BORD NA MONA PLC

**OBJECTION TO THE PROPOSED DECISION ISSUED FOR
THE DRUMMAN MATERIALS RECYCLING & WASTE
TRANSFER FACILITY W0275-01**

DECEMBER 2013

Abstract: This document presents Bord na Móna PLC's objection to the Proposed Decision (PD) for the Drumman Materials Recycling and Waste Transfer facility W0275-01.

Drawing Number LW09-660-04-100-004

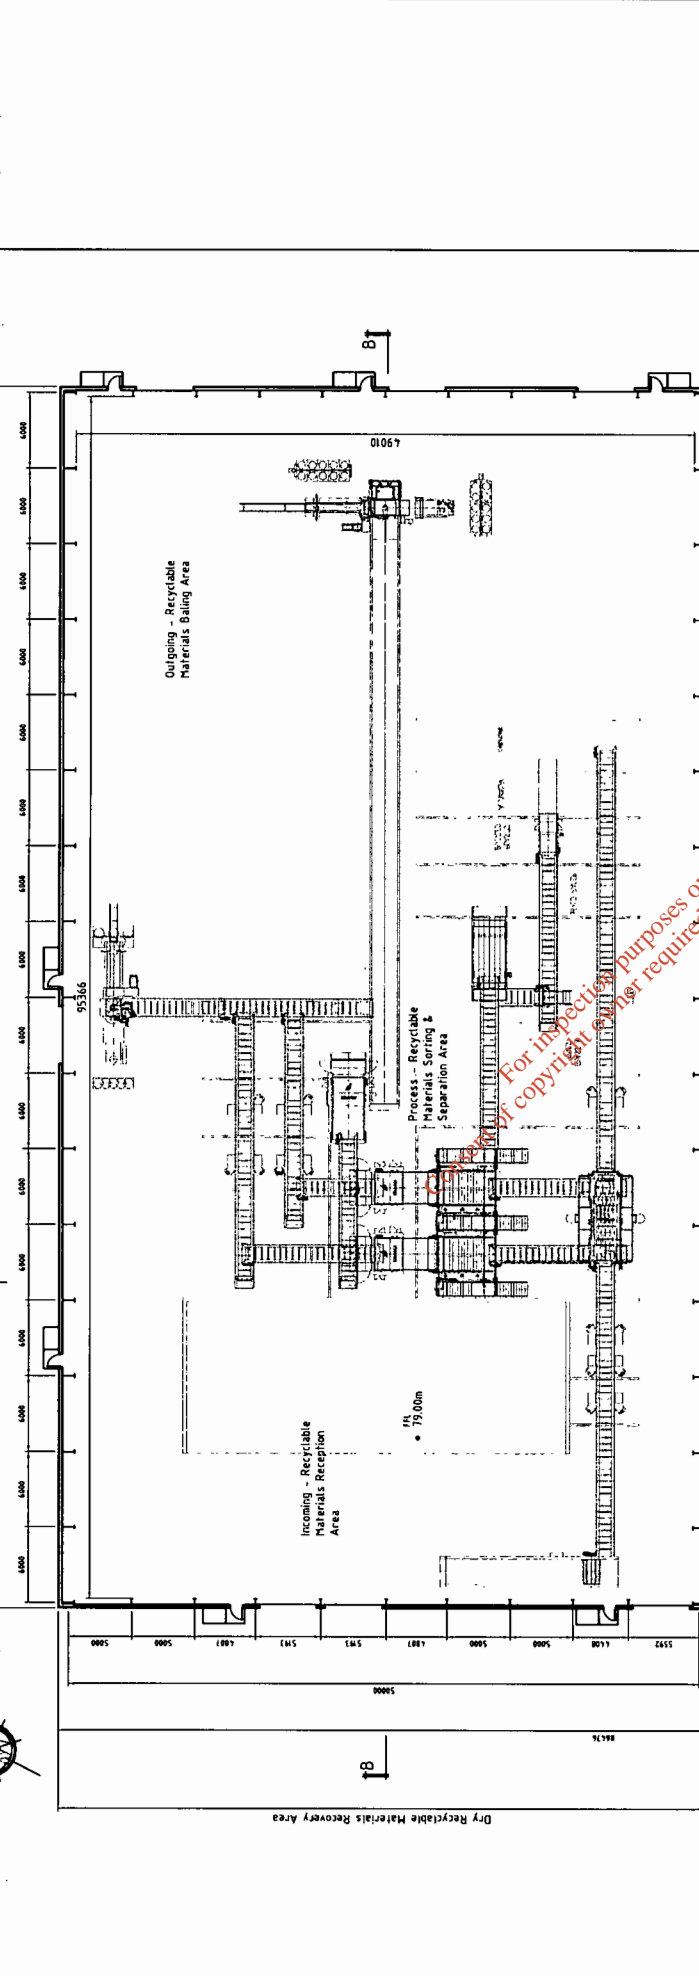
It is considered that Condition 3.10 does not accurately reflect the proposed operation of the facility, as outlined in the information submitted with the application. The facility Waste Reception & Processing Building will be divided into 3 distinct areas: the materials recovery area, the waste transfer area the biowaste reception area. Condition 3.12 of the licence addresses the biowaste storage area.

Construction and demolition (C&D) waste will be accepted within the waste transfer area, along with residual 'black bag' waste, where gross recovery will be undertaken on the C&D material, prior to being bulked up and transferred offsite. Therefore, it is considered more appropriate to refer to the waste transfer area as a whole, rather than specify the construction and demolition section within the waste transfer area.

For information, a floor plan drawing (Drawing Number LW09-660-04-100-004), submitted as part of the planning process, is included in Appendix 1 to this document to aid in visualising building layout.

Given that C&D waste will be accepted within a fully enclosed area of the Waste Reception & Processing Building, the requirements of Conditions 3.10.1 & 3.10.2 are provided for within the building.

It is submitted that Condition 3.10 should read as follows:

3.10 Waste Transfer Area

3.10.1 The licensee shall provide and maintain a fully enclosed waste transfer area for the acceptance, processing and storage of waste types identified in Schedule A2 of this licence.

Drawing Number LW09-660-04-300-005 RevC

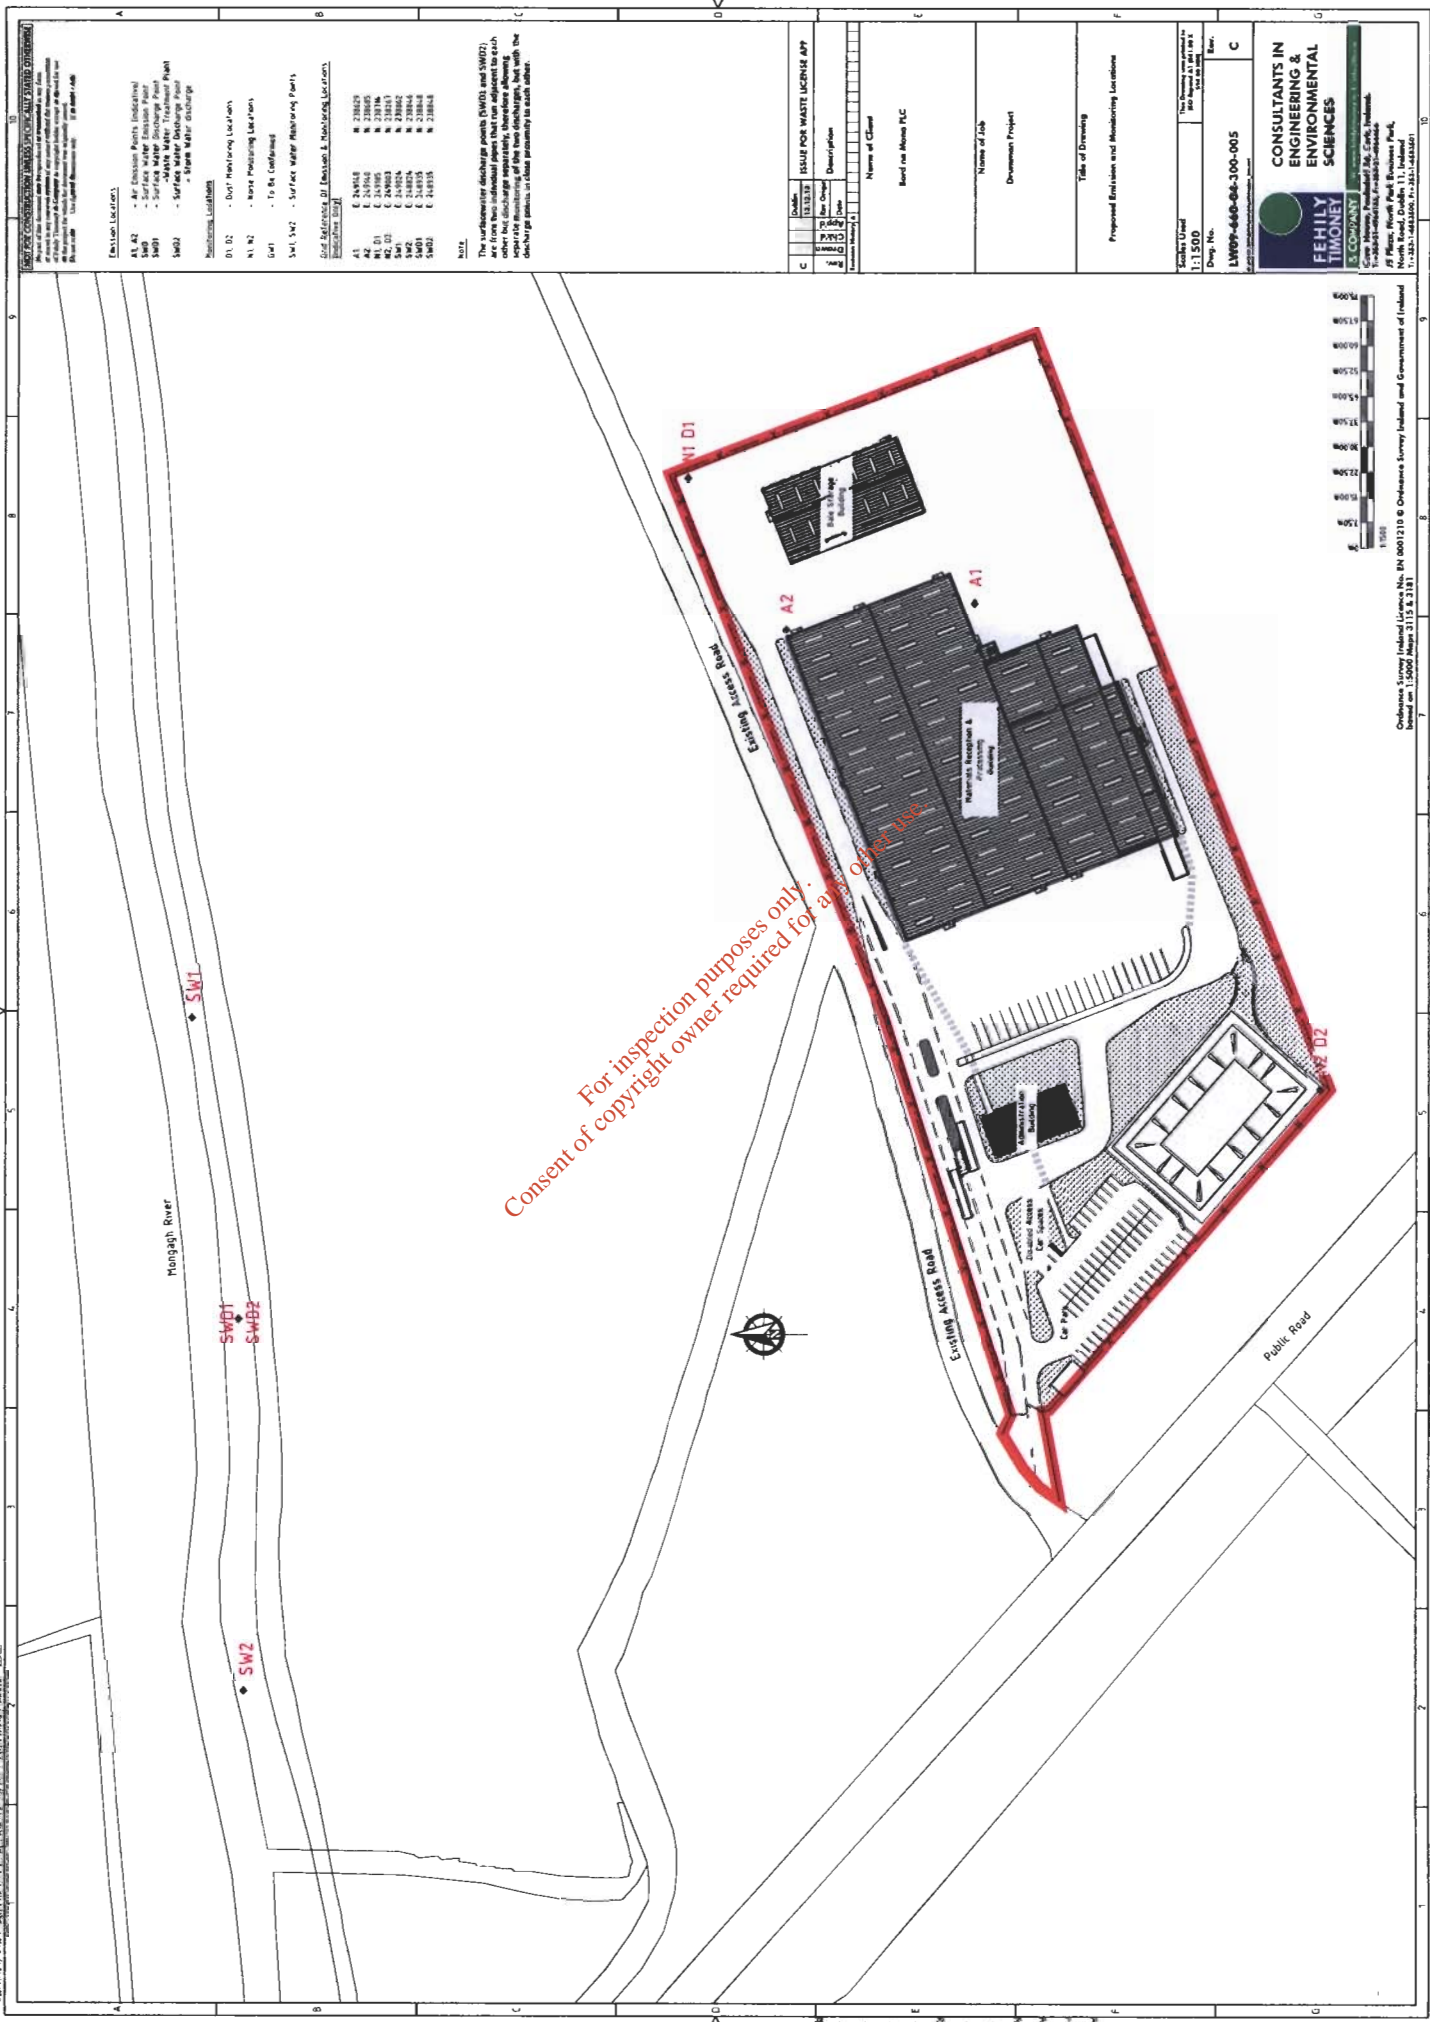
Schedule B.2 references SW1, as identified in Drawing Number LW09-660-04-200-025 Rev A.

Drawing Number LW09-660-04-200-025 Rev A was submitted as part of the Article 14 (2)(b)(ii) response, dated 15.08.13, but refers to a Site Services Plan.

Drawing Number LW09-660-04-300-005 Rev B was also submitted as part of the Article 14 (2)(b)(ii) response, and is titled 'Proposed Emission and Monitoring Locations'.

This drawing identified surfacewater monitoring points as SW1 and SW2 and surfacewater emissions points as SWD.

It is considered necessary to revise Drawing Number LW09-660-04-300-005 Rev B to provide clarity on surface water monitoring and emission locations. Drawing Number LW09-660-04-300-005 Rev C is included in the Appendix 2 to this document to provide clarity.

In summary, Drawing Number LW09-660-04-300-005 Rev C indicates the following:

- SW1 Downstream surfacewater monitoring location
- SW2 Upstream surfacewater monitoring location
- SWD1 Emission location - waste water treatment plant
- SWD2 Emission location - stormwater discharge

To this end, Schedule B2 should be amended to identify the Emission Point Reference Number as "SWD1, as per Drawing Number LW09-660-04-300-005 Rev C."
